**Attachment 9**  
**NRC3-12-0003**  
(17 pages)

**Response to RAI Letter No. 70**  
**(eRAI Tracking No. 6244)**

**RAI Question No. 03.07.01-7**

**Response to RAI Letter No. 70**  
**(eRAI Tracking No. 6244)**

Figure 2: Response spectral shapes (5% damping) for Fermi 3 HF and LF controlling earthquakes based on NUREG/CR-6728 CEUS rock spectral shapes.

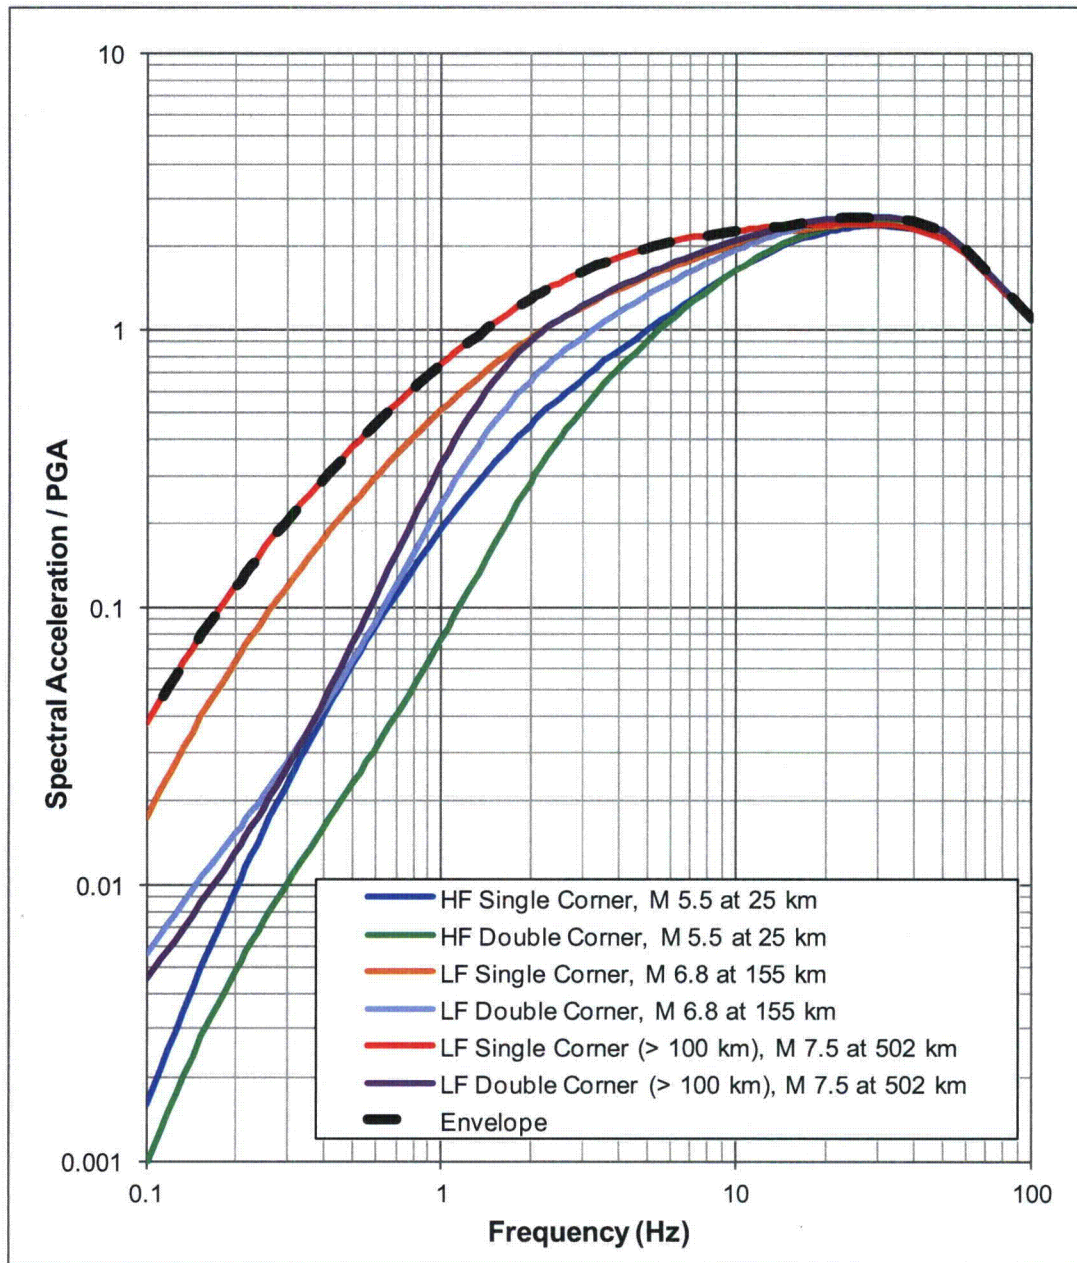
*However, the guidance in SRP 3.7.1 and ISG-017 also indicates that, to satisfy the regulatory requirements, the minimum horizontal PGA of 0.1g should correspond to a smooth broad-band spectral shape such as the one described in RG 1.60. Therefore, the applicant is requested to provide in the FSAR comparison plots of the RB/FB and CB horizontal FIRS with the RG 1.60 horizontal spectrum anchored at 0.1 g, which demonstrate that the RB/FB and CB horizontal FIRS envelope the RG 1.60 spectrum at all frequencies of interest. The staff needs this information to confirm that the site-specific seismic input used in the site-specific SSI analysis meets 10 CFR Part 50, Appendix S.*

Section 3.1 of NUREG/CR-6926 suggests that the CEUS spectral shapes provided in NUREG/CR-6728 (McGuire et al., 2001) are more appropriate for hard rock sites. Figure 2 shows CEUS rock site spectral shapes developed using the relationships presented in NUREG/CR-6728. These shapes are developed using the average of the  $10^{-4}$  and  $10^{-5}$  controlling earthquake magnitudes and log average of the controlling earthquake distances. NUREG/CR-6728 presents spectral shapes based on two alternative models for the shape of the earthquake source spectra: a single corner model and a double corner model. Figure 2 shows both of these spectral shapes. A single enveloping spectral shape is constructed, as shown by the heavy dashed line on Figure 2. Figure 1 shows that the RB/FB and CB SSI FIRS are greater than the enveloping NUREG/CR-6728 spectral shape from Figure 2 scaled to a PGA of 0.1g.
